**COMMENTS, RESPONSES TO COMMENTS, AND ERRATA
ON THE
SUSTAINABLE COMMUNITIES ENVIRONMENTAL
ASSESSMENT/INITIAL STUDY (SCEA/IS)**

**FOR THE
TRACKSIDE CENTER PROJECT
901-919 3RD STREET, DAVIS, CA**

NOVEMBER 2017

Prepared By:
City of Davis
Community Development & Sustainability Department
23 Russell Boulevard, Suite 2
Davis CA 95616

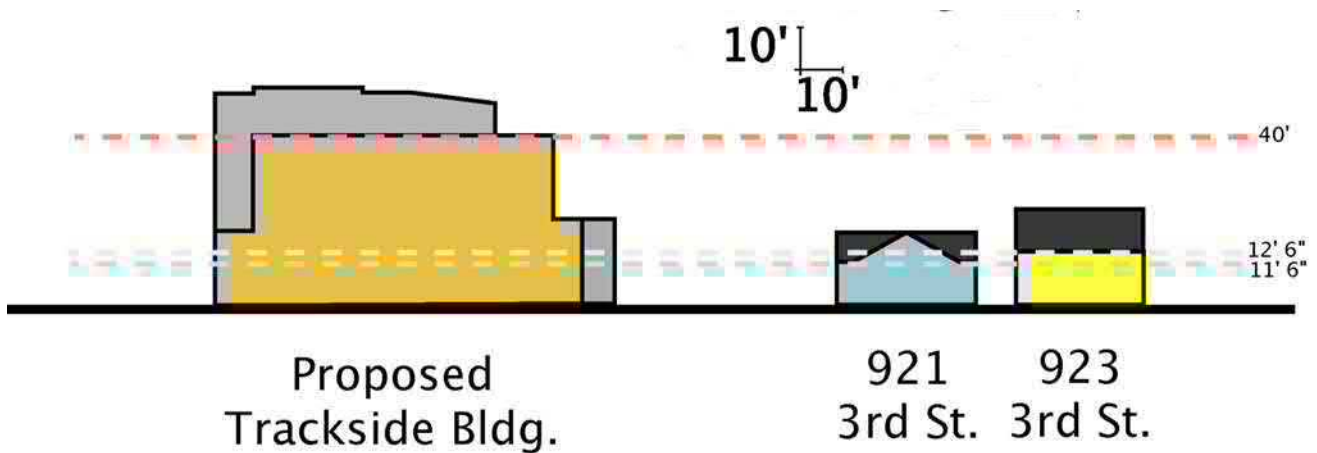
The DDTRN Design Guidelines for mixed use mass and scale state: "A building shall appear to be in scale with traditional single-family houses along the street front." (See, DDTRN Design Guidelines, pg.58.) The word "shall" is understood to imply a mandatory provision which must be followed. The Project is a mixed use building located within the Downtown and Traditional Neighborhood Overlay District (See, IS, pg.3), and is therefore subject to the DDTRN Design Guidelines. Figure 1 below is a scale drawing of the Project, in context of the adjacent single-family houses along Third Street. The Project's façade is more than three times as tall as the façades of the adjacent houses; and the Project's façade is more than twice as wide as the façades of the adjacent houses. The Project does not "... appear to be in scale with traditional single-family houses along the street front."

Other Project inconsistencies with the DDTRN Design Guidelines for mixed use mass and scale are detailed in the Compliance Table below. I have copied the second column of lettered Design Elements from a compliance table produced by City of Davis planning staff. (See, July 19, 2017 Planning Commission Staff Report, Attachment 11, pg. 05A 86-87.) I have used the Project's data from the City of Davis' Trackside Center Project website, as well as measurements of the adjacent homes along Third Street, to complete the third column. (See, Figure 1 above.)

Based on figure 1, the Project does not incorporate a "...careful transition to adjacent single story buildings". The Project is therefore inconsistent with the DDTRN Design Guidelines for the Third Street Special Character Area. Based on figures 1 and 2, the Project has noticeably different mass and scale, compared to buildings to the Project's east and west, and therefore does not "...improve the visual and land use transition from the Commercial

Figure 3. Looking west at the alley, between Third Street (at left margin) and Fourth Street (at right margin). The figure was made by Larry D. Guenther using methods described for Figures 1 and 2.

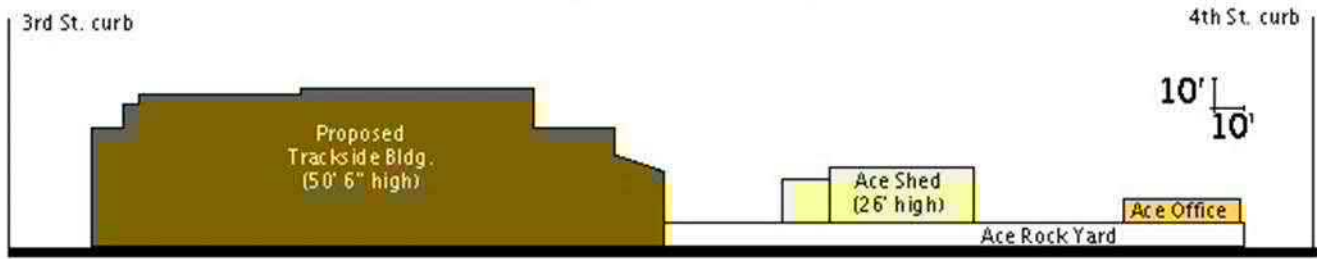
Figures 3 and 4 show the Project, in context of structures lying to the north and east of the Project.

Based on figures 1, 2, 3 and 4, the Project is not of "...a scale in keeping with the existing city character." The Project is therefore inconsistent with General Plan Vision 2, item 4. The Project does not "... maintain [a] scale transition..." and is therefore inconsistent with General Plan Land Use Principle 4. The Project does not exhibit "...an architectural 'fit' with Davis' existing scale..." and is therefore inconsistent with General Plan Policy UD 2.3. Finally, the Project does not make "...a scale transition between intensified land uses and adjoining lower intensity land uses" and is therefore inconsistent with General Plan Policy UD 2.3, Standard a).

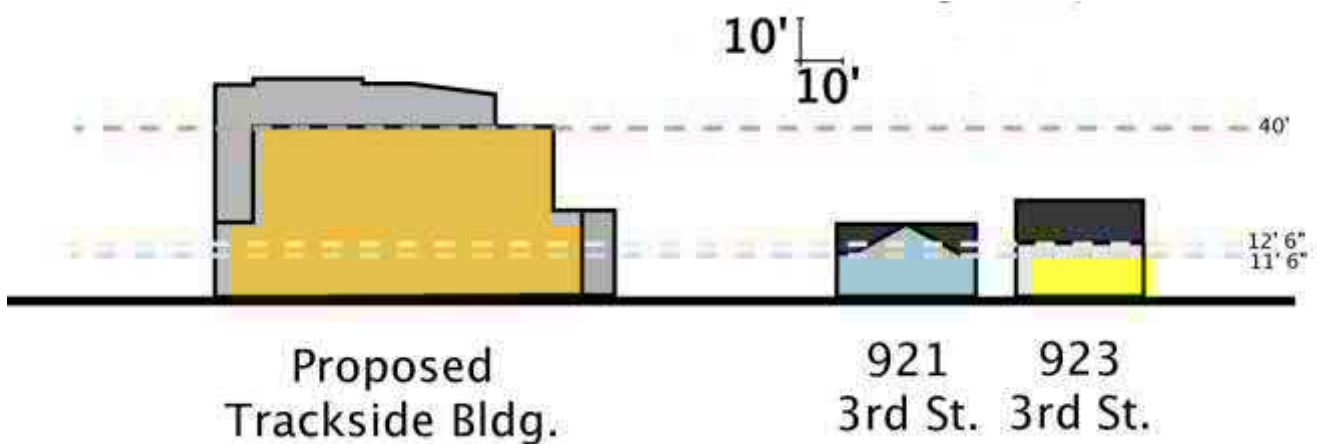
| PROJECT ELEMENT | CITY OF DAVIS LAND USE POLICY | PROPOSAL, LAND OWNED BY TRACKSIDE PARTNERS |
|--------------------|---|--|
| Fit Within Context | “Require an architectural ‘fit’ with Davis’ existing scale for new development projects. There should be a scale transition between intensified land uses and adjoining lower intensity land uses.” (Gen. Plan p.159) | See Figs. 3-5 and accompanying text below. |

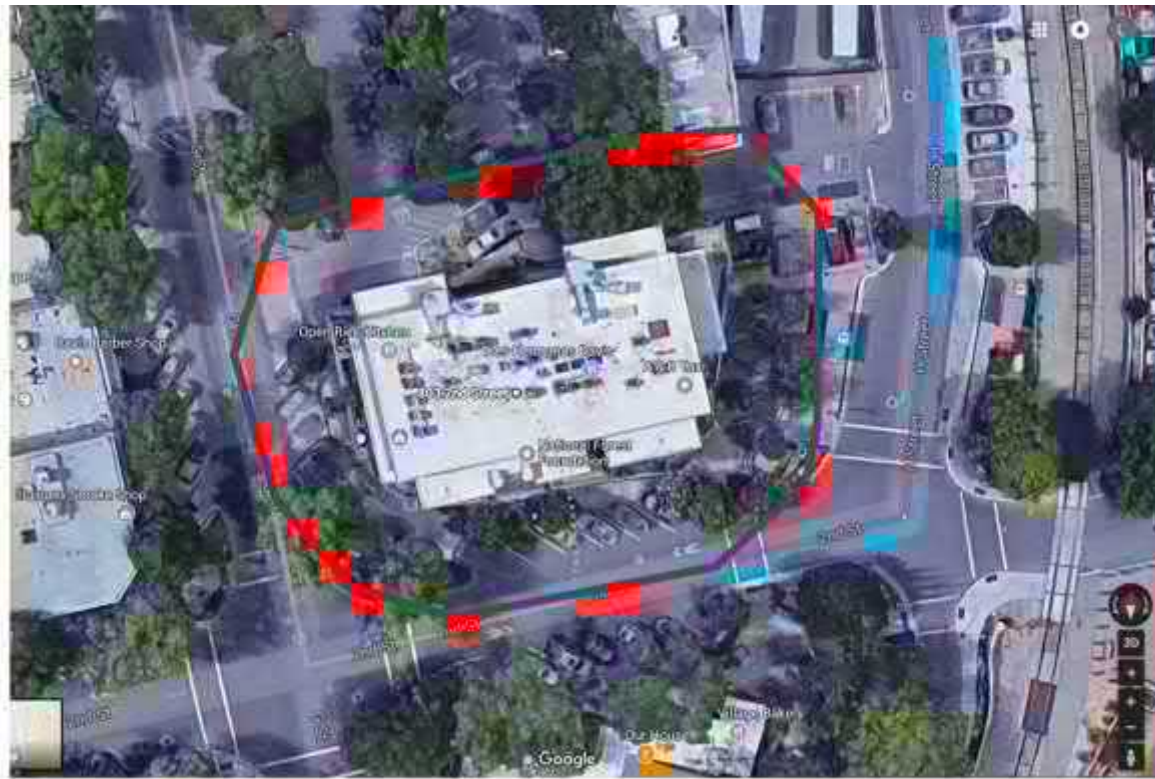
The Chen Building is 48'8" tall, with 23,703 sq. ft. building area (City of Davis Planning Division data), while the Trackside proposal is 50'6" tall with 47,983 sq. ft. building area (City of Davis Trackside Center website). Though it seems obvious, I will state it: a project equivalent to two Chen Buildings attached to each other should not be built adjacent to single-story, traditional homes.

A photo simulation, showing distances from the Chen Building equal to distances between the Trackside project and neighboring properties, is below (Figure 6).

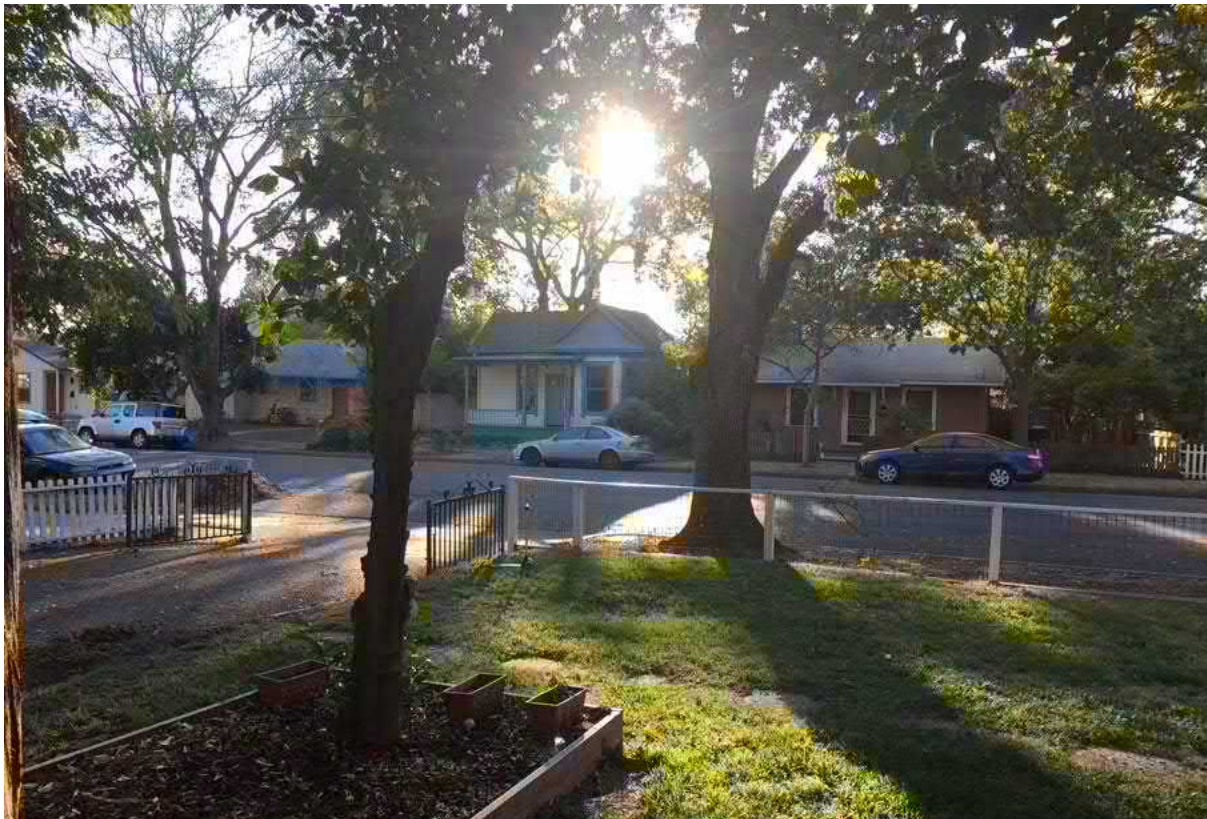
Neither assertions is correct and both are contracted by shading ‘facts’ in the report itself and provided below, which prove the proposed building will have a significant impact on the availability of sunlight on to our front porch during the late afternoon and early evening hours. The study claims that these areas are already shaded by the veranda or trees, but this is not true in the 1-2 hours (depending on the year) before sundown, when the sun dips below the tree line and the sun comes lights up the front porch, which provides most of this house’s distinguishing architectural features.

The picture below was taken in the front of our house on the 7th of November at 3:38pm(!) when I first realised the extent of the impact of the proposed building the light coming on to the property. While the expert report suggests that the impact will be minimal, it is pretty clear here that it will be impacting sunlight hitting one of Davis’ best registered Landmark Resources quite early in the day. The building will essentially be hidden in shadow from this point onwards, significantly dulling the appearance of the resource compared to its appearance with relatively good, lateral sunlight.

enjoy direct sunlight in the late afternoon that would be subject to significant additional shadowing from the proposed building due to its violation of the neighbourhood's design guidelines.

Figure 1 from the GeoTracker website showing Hazardous Materials sites within one mile of the Trackside Center site..

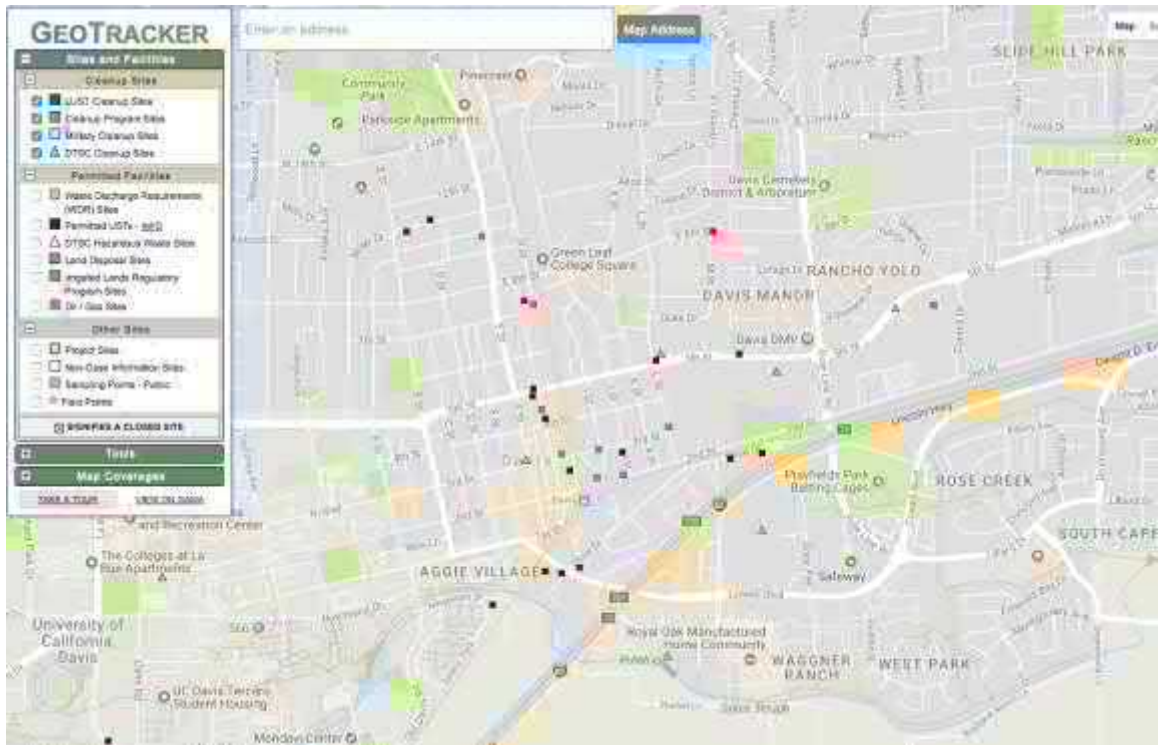
While the Geotechnical report and Phase I Environmental Site Assessment mention the 3rd St. site (SL185822944) and the Olive Street LUST (Leaking Underground Storage Tank, T0611318306), they fail to mention any other sites surrounding the Trackside Center. In addition to the two sites mentioned, there are seven cleanup sites, two LUST's (Leaking Underground Storage Tank), and three DTSC clean-up sites within 1 mile of the trackside Center site (Figure 1). There is no mention of any of these sites, nor any mitigation description or effects of these sites. Even of the two sites mentioned, there is no mitigation of possible effects at the Trackside site inferred, stated, or implied.

The appendix and other arguments show that all four of these points are false. Figure 1 shows three sites located within 700 feet of the Trackside Center site in addition to the two mentioned in the Phase I report (from the GeoTracker website). These additional sites are not mentioned in the report and no evidence is given that the sites mentioned, or those not mentioned, will not affect the Trackside site. It is noted that the four closest sites completely surround the Trackside Center. 'The Enterprise' site (SL185832945) is located to the west, the 'Davis Center Project' (SL0611328818) is located to the northwest, the 'I Street Development Co.' (SL185822944) is located to the east, and 'Union Pacific Railroad – Davis Amtrak Station' (SL185452916) is located to the south.
